Appendix I of RNTPC
Paper No. A/SK-CWBS/48

**APPLICATION FOR PERMISSION
UNDER SECTION 16 OF
THE TOWN PLANNING ORDINANCE
(CAP.131)**

(b) Intended use/development 有意進行的用途/發展	<p>Proposed Public Utility Installation (HV Pillar) and Associated Excavation of Land 擬議公用事業設施裝置（高壓配電箱）和相關挖土工程</p>

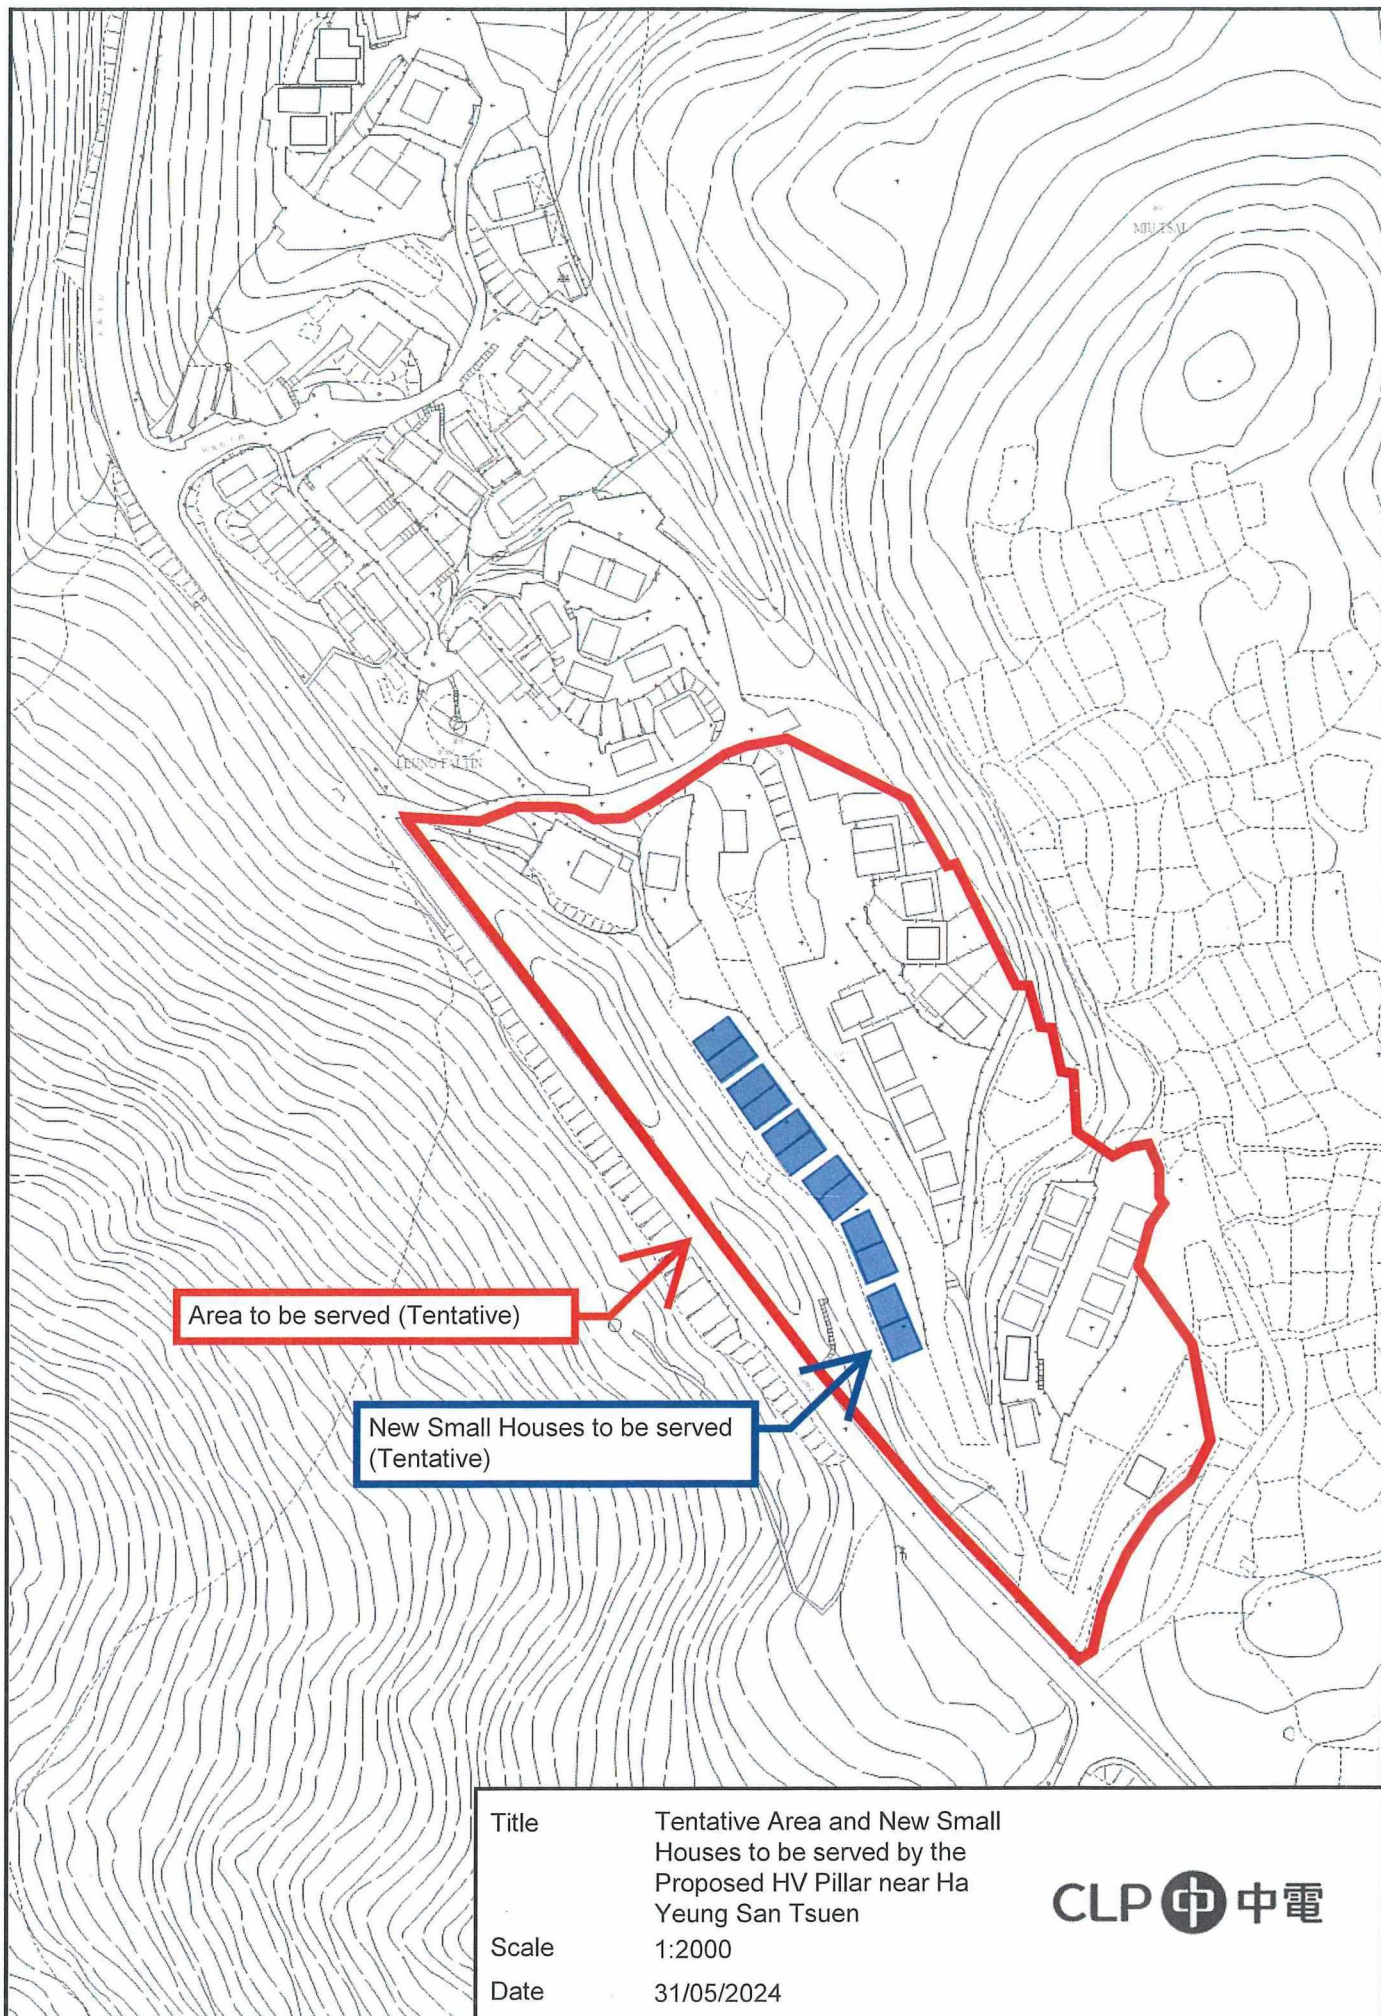
Further to the tele-conversations with Ms. Sylvia Lam and Mr. Benjamin Lee of your department regarding the subject planning application, please find the following information prepared to address the comments concerned, which supersedes my email dated 6 June 2024.

1. Tentative Service Area of the Proposed HV Pillar (as attached)
2. Tentative Delivery Routing to the Service Location (as attached)
3. Please note that there are existing underground cables along Clear Water Bay Road.
4. Site Photos (as attached)
